Access Compliance Report Public Rights-of-Way (Pedestrian Signals)

Intersection ID: N/A	Main Street:	Cross Street: N/A	Location: N/A
ADA ID: 5E195C98FF38	Signal Type: One Push Button-Non APS	Overall Compliance: No	Severity Score: BTN 1: N/A BTN 2: N/A No BTN: N/A
Codes/Mitigation Info/Possible Solution		Field Measurements/Component Compliance

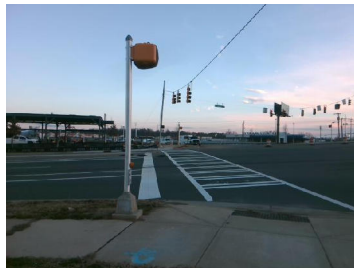
Compliance	Description	Data	Compliance	Description	Data
	Button Count	Button1	Yes	Distant to Additional Button (in)	390.0
	Additional Button Present?	Yes		Additional Button ID	AE328F9CC52A
N/A	Signal Buttons Required?	N/A	N/A	Additional Ped Posts Required	N/A
	How Many Ped Street Xings?	2		Located In An Island/Median?	No
N/A	B 1 Sign Present?	Yes	N/A	B 2 Sign Present?	N/A
Yes	B 1 Sign Purpose?	Yes	N/A	B 2 Sign Purpose?	N/A
Yes	B 1 Sign Lettering & Contrast?	Yes	N/A	B 2 Sign Lettering & Contrast?	N/A
Yes	B 1 Parallel To XWalk?	Yes	N/A	B 2 Parallel To XWalk?	N/A
Yes	B 1 PAR to Button?	Yes	N/A	B 2 PAR to Button?	N/A
Yes	B 1 PAR to XWalk?	Yes	N/A	B 2 PAR to XWalk?	N/A
Yes	B 1 Clear Floor Space?	Yes	N/A	B 2 Clear Floor Space?	N/A
N/A	B 1 FWD Approach?	Yes	N/A	B 2 FWD Approach?	N/A
N/A	B 1 FWD Approach Constrained?	No	N/A	B 2 FWD Approach Constrained?	N/A
No	B 1 FWD Approach Reach (in)	6.0	N/A	B 2 FWD Approach Reach (in)	N/A

N/A	B 1 FWD Approach Width (in)	N/A	N/A	B 2 FWD Approach Width (in)	N/A
N/A	B 1 FWD Approach Obstruction?	Yes	N/A	B 2 FWD Approach Obstruction?	N/A
N/A	B 1 FWD Approach Obstruction Dist (in)	4.0	N/A	B 2 FWD Approach ObstructionDist (in)	N/A
N/A	B 1 PARA Approach?	Yes	N/A	B 2 PARA Approach?	N/A
N/A	B 1 PARA Approach Constrained?	No	N/A	B 2 PARA Approach Constrained?	N/A
Yes	B 1 PARA Approach Reach (in)	6.0	N/A	B 2 PARA Approach Reach (in)	N/A
N/A	B 1 PARA Approach Width (in)	N/A	N/A	B 2 PARA Approach Width (in)	N/A
N/A	B 1 PARA Approach Obstruction?	Yes	N/A	B 2 PARA Approach Obstruction?	N/A
N/A	B 1 PARA Approach Obstruction Dist (in)	4.0	N/A	B 2 PARA Approach ObstructionDist (in)	N/A
Yes	B 1 Clear Floor Space Slope (%)	3.1	N/A	B 2 Clear Floor Space Slope (%)	N/A
Yes	B 1 Clear Floor Space XSlope (%)	0.2	N/A	B 2 Clear Floor Space XSlope (%)	N/A
N/A	B 1 PAR Slope (%)	4.0	N/A	B 2 PAR Slope (%)	N/A
Yes	B 1 Height (in)	40.0	N/A	B 2 Height (in)	N/A

Yes	B 1 Clear Xing Direction?	ClearlyMarked	N/A	B 2 Clear Xing Direction?	N/A
	B 1 Crossing Direction	To N		B 2 Crossing Direction	N/A
No	B 1 DistanceTo XWalk (in)	82.0	N/A	B 2 DistanceTo XWalk (in)	N/A
Yes	B 1 DistanceTo Curb (in)	60.0	N/A	B 2 DistanceTo Curb (in)	N/A
Yes	B 1 Diameter (in)	2.0	N/A	B 2 Diameter (in)	N/A

Possible Solutions: Replace Signal Push Button With APS Button on New Post. Remove & Relocate Sign.

PROW/ADA: TMUTCD 4e.08, R406.2
